## Correction: CO<sub>2</sub> decomposition in a packed DBD plasma reactor: influence of packing materials

Correction for 'CO<sub>2</sub> decomposition in a packed DBD plasma reactor: influence of packing materials' by Debjyoti Ray *et al.*, *RSC Adv.*, 2016, 6, 39492–39499.

Fig. 3 Lissajous figure for DBD reactor as a function of voltage.

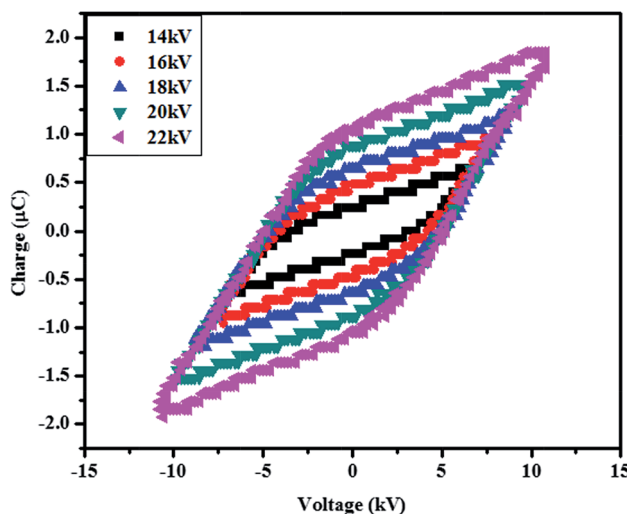
The authors would like to make the following changes to their manuscript to correct errors in their original manuscript which were due to electrical interference which was present in the earlier experiments. An explanation of the interference and its effects is given in the following paragraph.

Fig. 3, 4, 5 and 6 should be replaced with the following figures:
